ADDENDUM NUMBER 1

NOTIFICATION DATE:	BID TITLE:	BID NUMBER:	BID OPENING DATE & TIME:
02/27/18	Geothermal Cooling Water Supply and Facility Improvements	18-035	03/20/2018 2:00PM

- Attached find Exhibit A that replaces existing drawings M-000, M-001, M-002, M-003 from the original bid document with revised drawings M-000, M-001, M-002, and M-003.

M-002
SHEET NUMBER

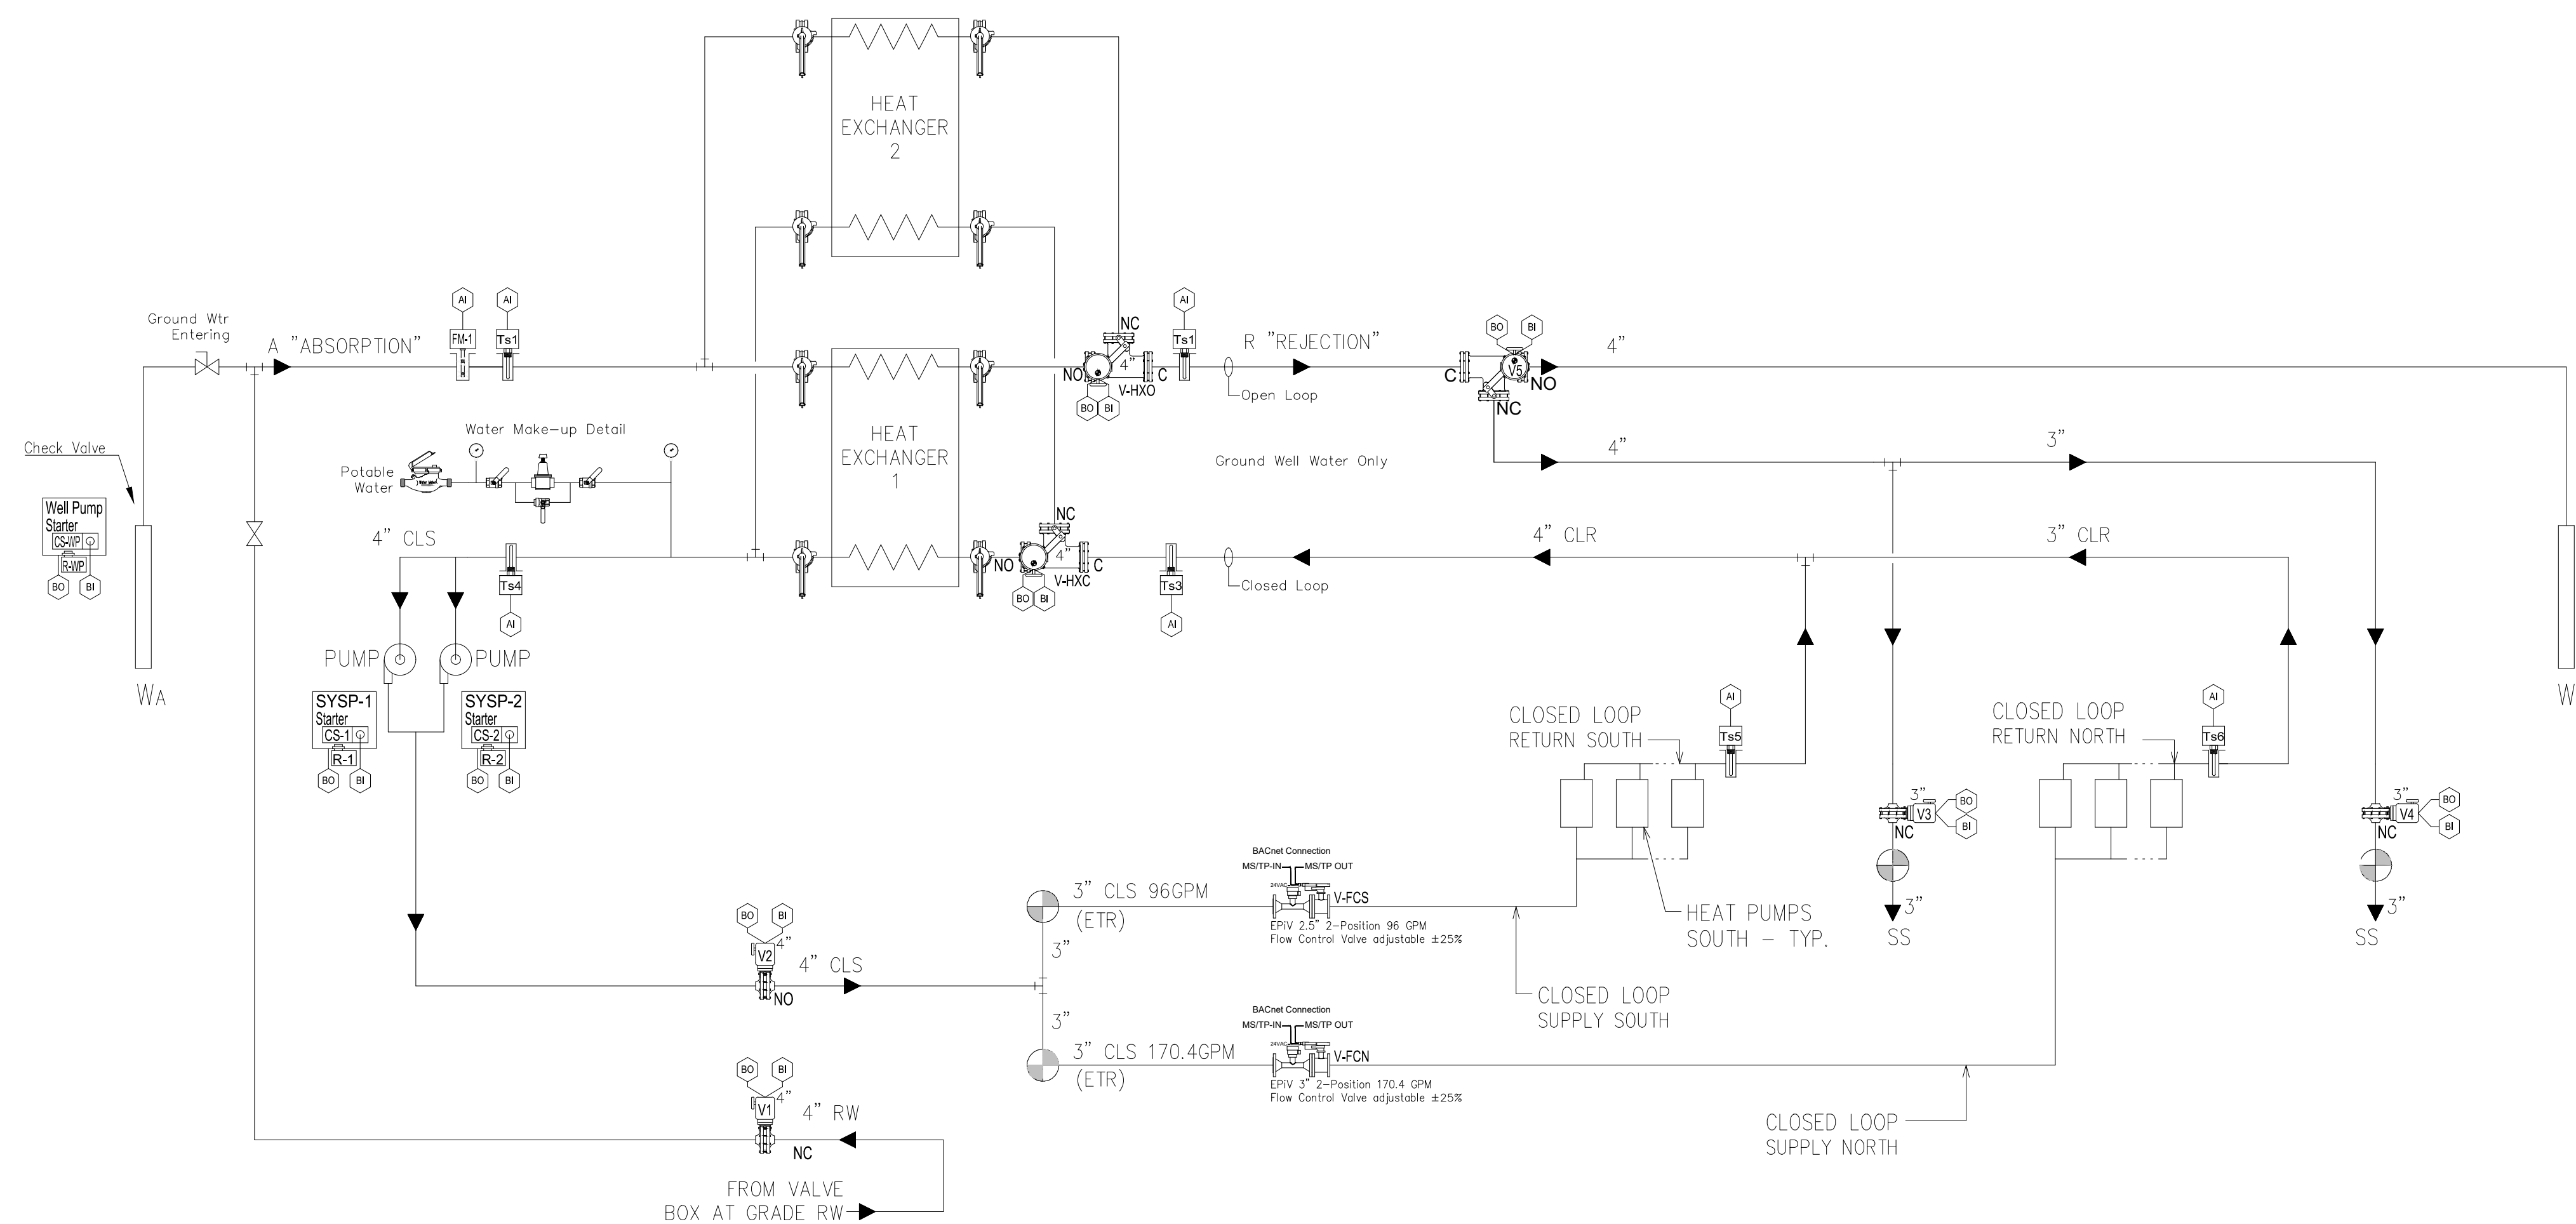
DIAGRAM
UPDATED.
